DOCKETED				
Docket Number:	19-BSTD-03			
Project Title:	2022 Energy Code Pre-Rulemaking			
TN #:	236762			
Document Title:	Parker Boiler Co Comments - 2022 Energy Code Pre-rulemaking Title 24 Part 6			
Description:	N/A			
Filer:	System			
Organization:	Parker Boiler Co			
Submitter Role:	Public			
Submission Date:	2/12/2021 2:43:44 PM			
Docketed Date:	2/12/2021

Case Report 2022 Title 24 Part 6 Final Case Report Codes & Standards Enhancement Initiative, California Statewide Utility Codes & Standards

Docket # 19-BSTD-03 2022 Energy Code Pre-rulemaking

3.) Seismic -Food / Drink Process

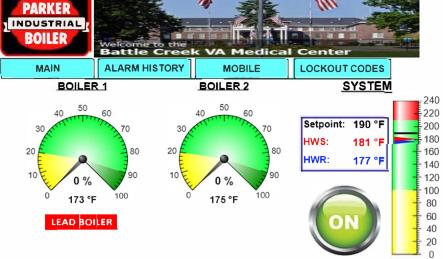
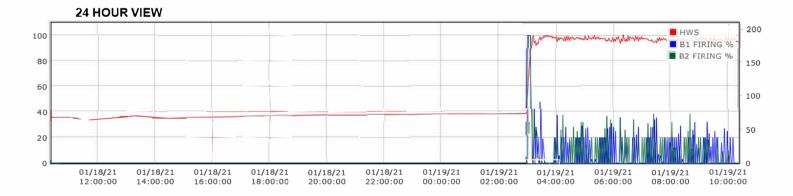
As you can see from 7-day & 24 hour views the boilers seem to be started daily on weekdays and the daily hourly use of the boiler likely depends on product demand.

4.) Spica - Process to Make Varnish

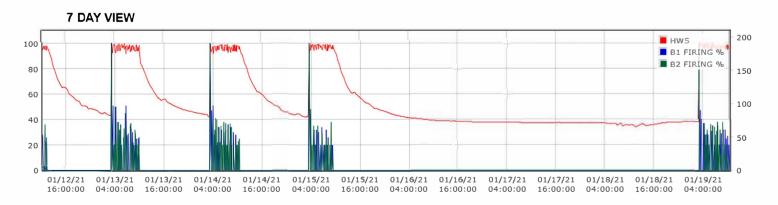
As you can see form the 7 day & 24 hour views the boiler is started perhaps 1-3 times per week.
